RE: M-Keds Plat 1 Lot 2 Site Plan

The Development Services Department is in receipt of a proposed Site Plan for M-Keds Plat 1 Lot 2. Based on the review of the provided submittal materials, staff have the following comments:

HOPE COMMERCIAL PLAT 2

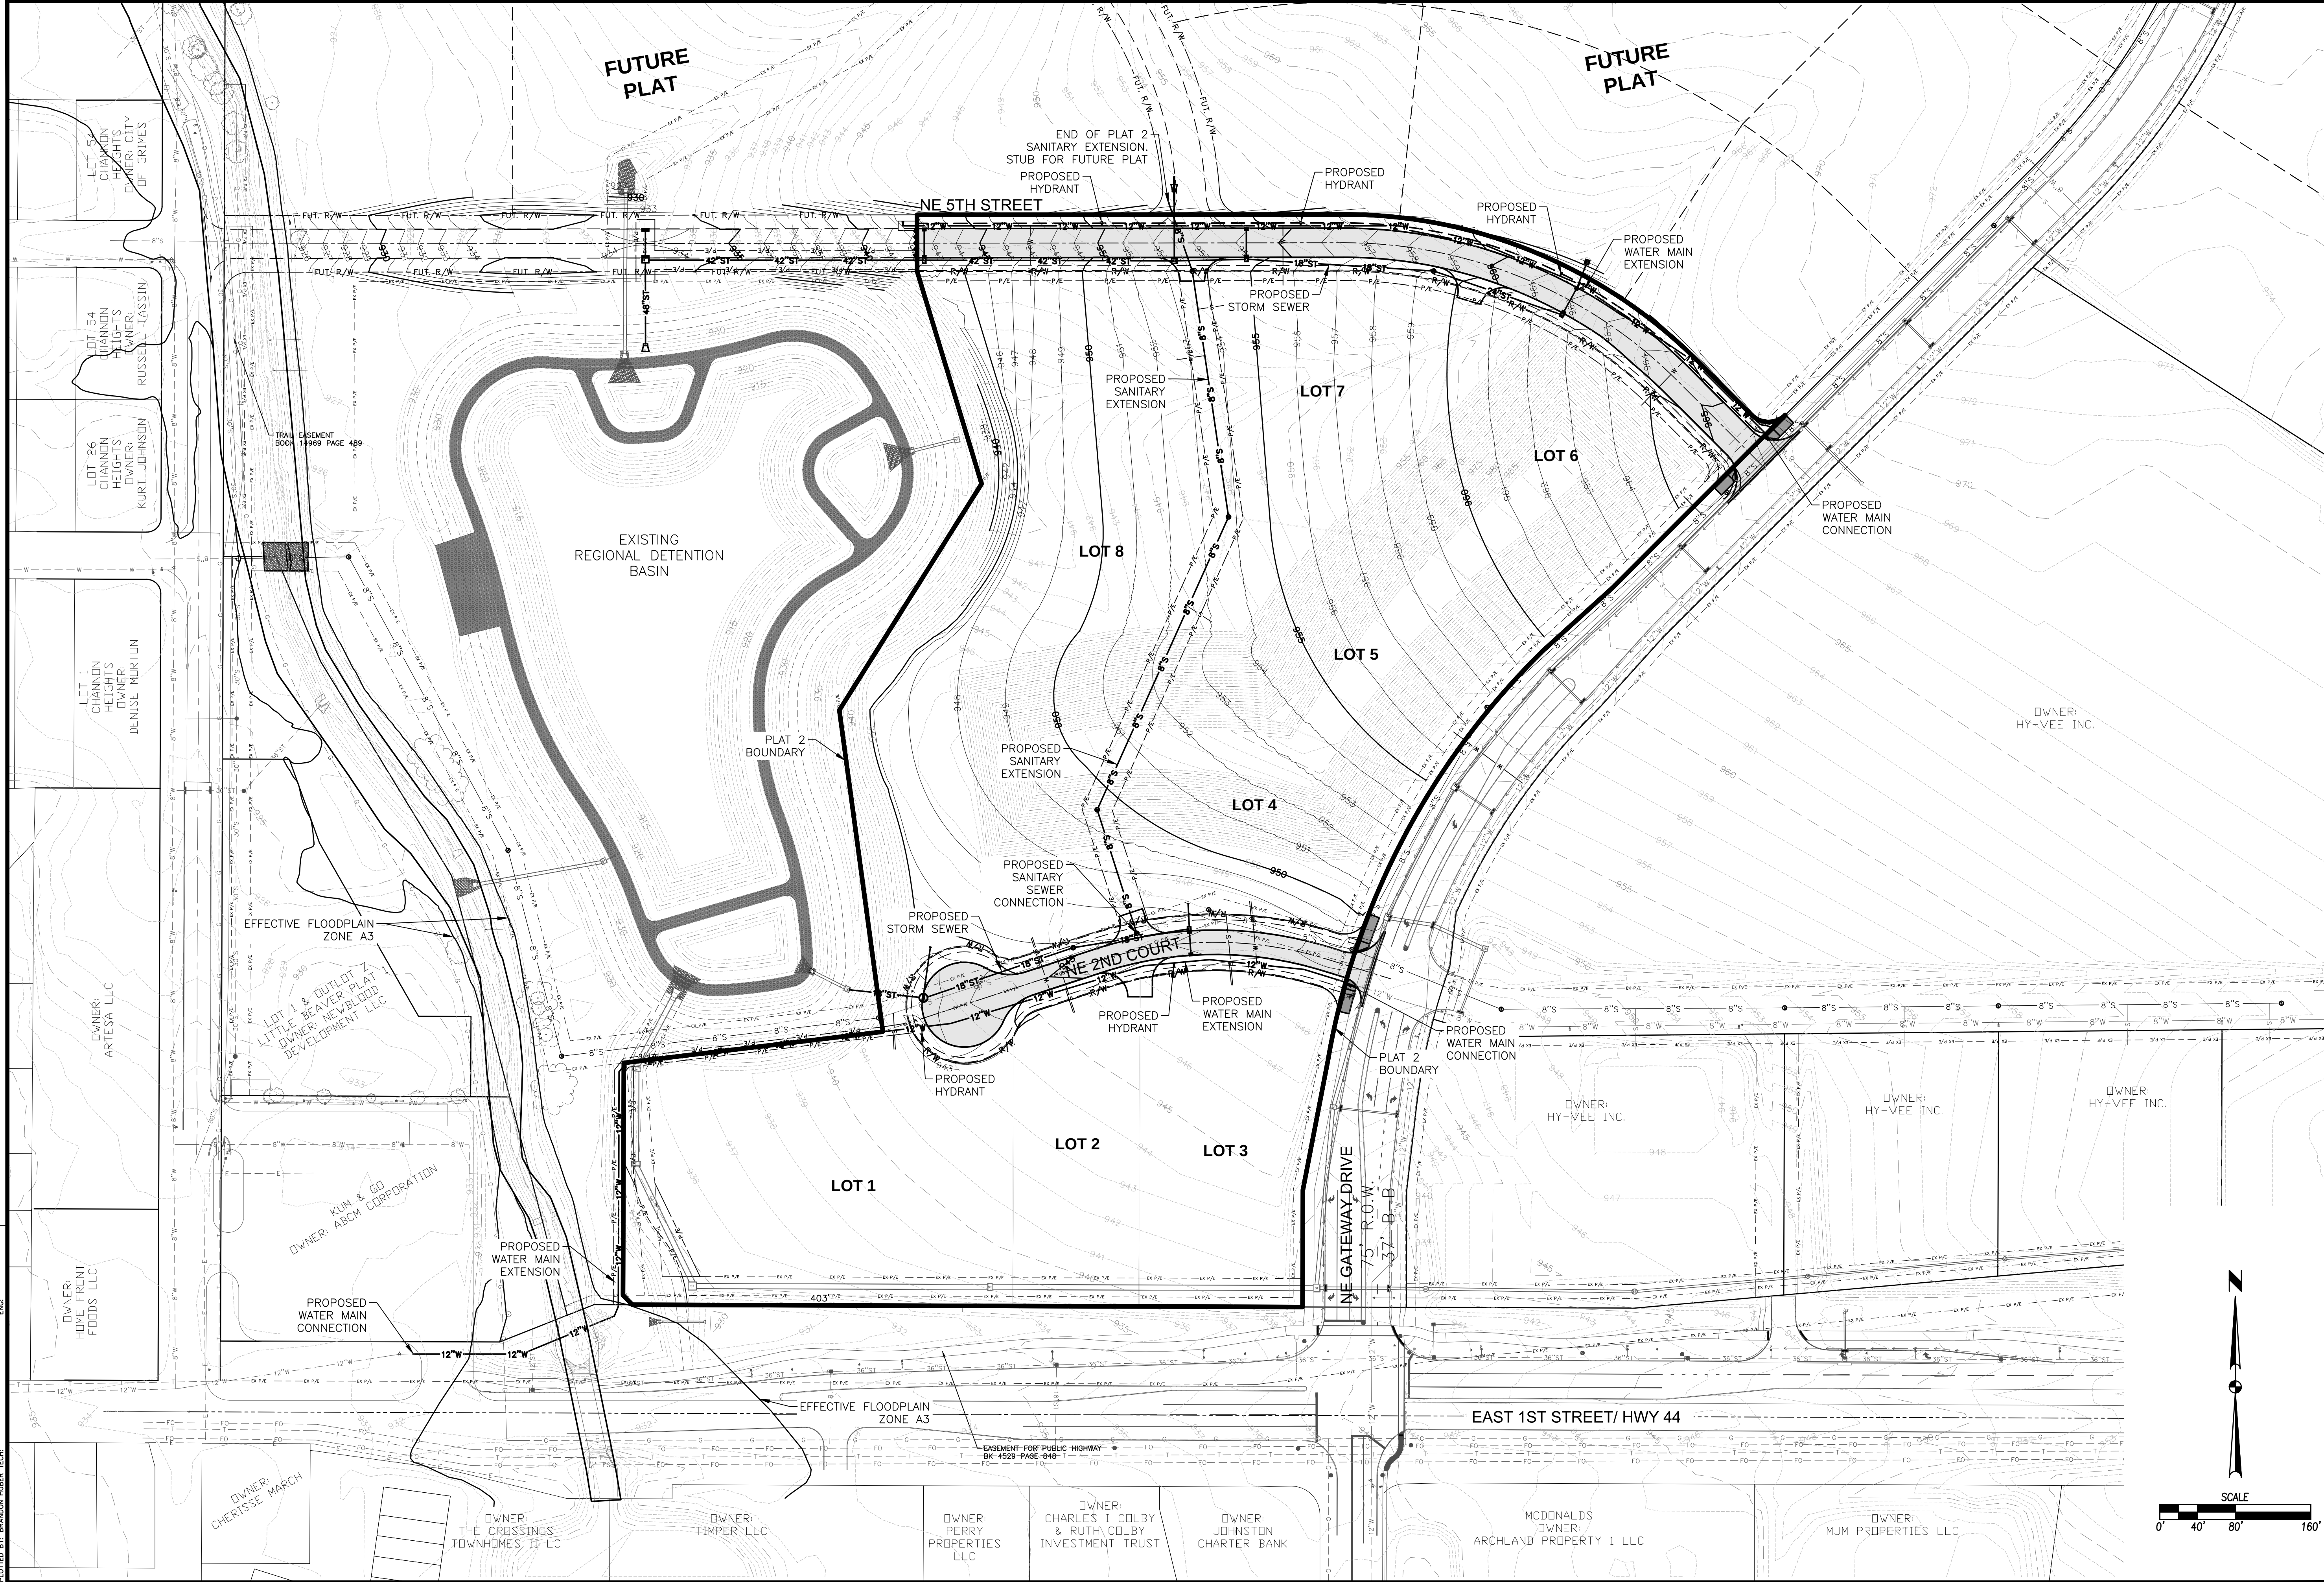
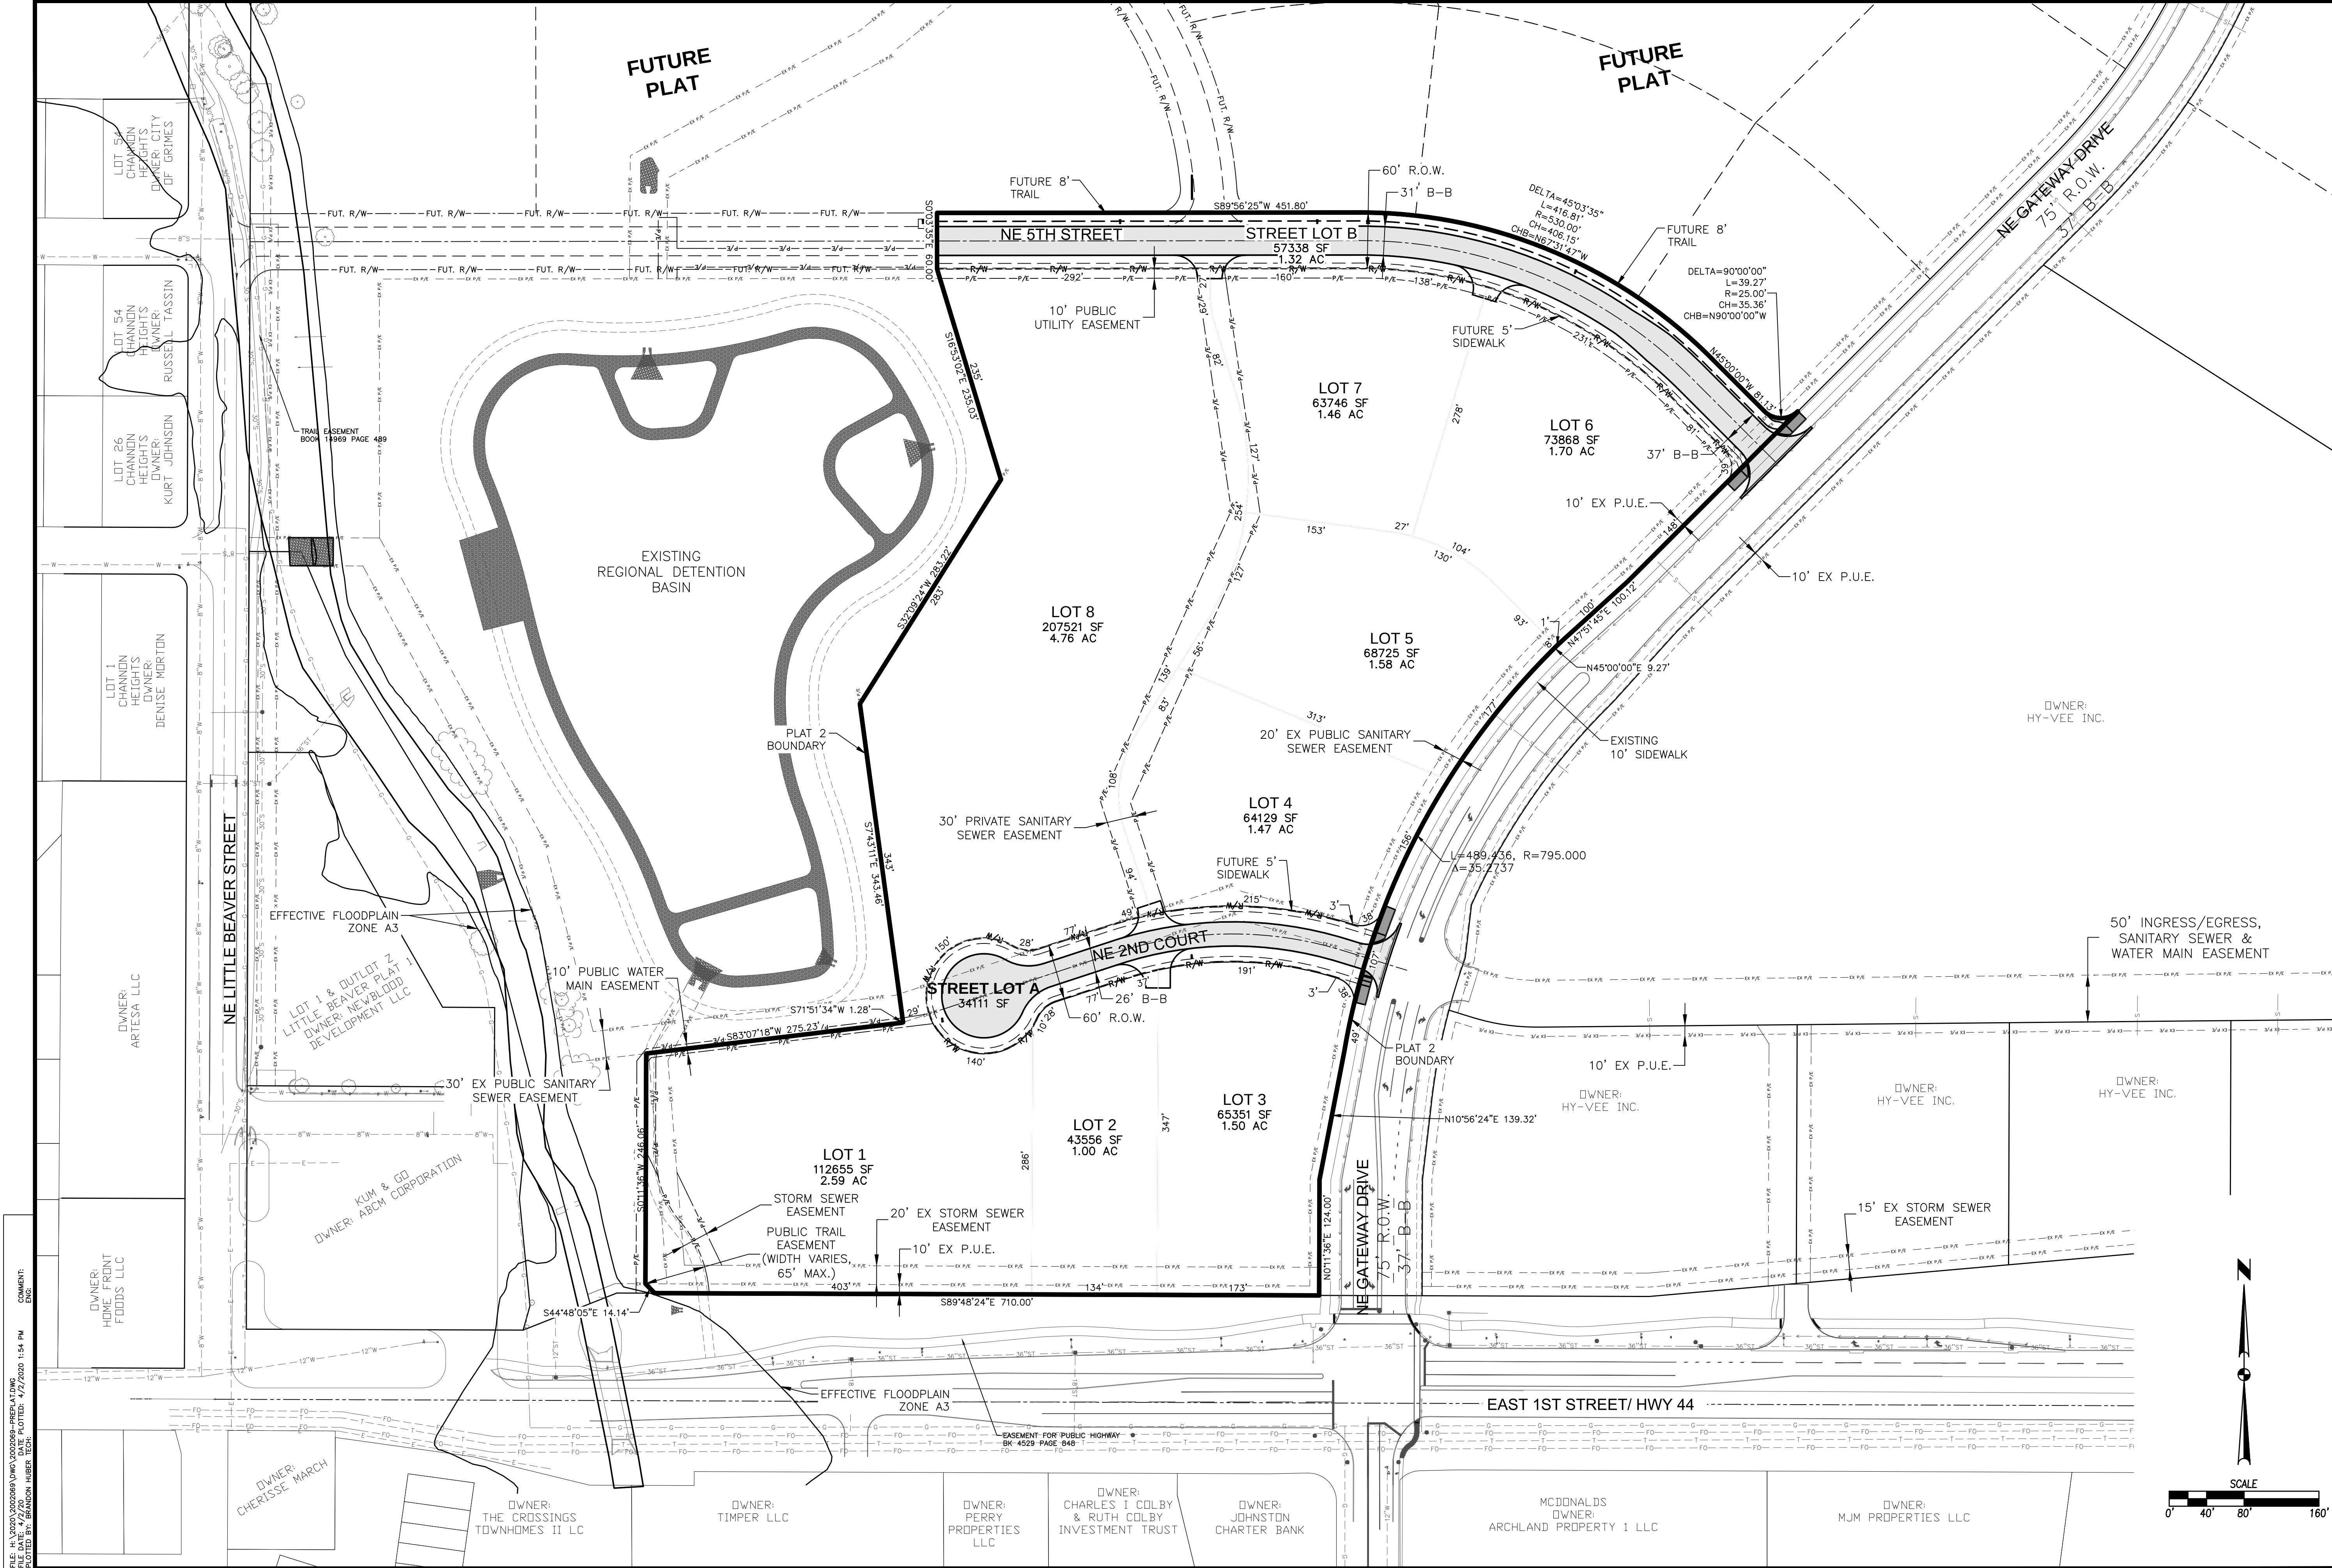
- ~~1. Staff questions if the applicant is pursuing the RI/RO off 1st Street. If so, staff will contact the DOT for next steps.~~
- ~~2. Staff questions how internal ingress/egress will be handled through the sites.~~
- ~~3. Please show intended points of access along the roadways.~~

4. ~~Staff questions if the applicant intends for the access point along NE Gateway at lots 6/7 to be full access. Where the median terminates is a bit awkward and may cause conflicts along the roadway.~~

5. ~~Show sidewalk along all public streets (both sides).~~ **Show 10' sidewalk along Gateway Drive. Per the PUD discussions, please show an 8-foot trail along the north side of NE 5th ST.**

6. ~~Please provide pedestrian connection to the trail around the water feature.~~ **What is the width of the trail easement? Please provide details for the width.**

7. ~~Please show required landscaping along the public streets.~~
8. ~~Staff is concerned with the width of Lot 3. At 110 feet of width, and the anticipated fast food user, circulation while maintaining the minimum bulk requirements may be challenging.~~

9. ~~Staff questions if MPE's are needed for Lot 1/2 and 9.~~
10. ~~Staff questions if a sidewalk easement is necessary for the cul-de-sac bulb.~~
11. **On the concept plan, please remove the driveway from Lot 4 to NE 2nd Ct. The driveway is too close to the other two intersections to the east and west.**
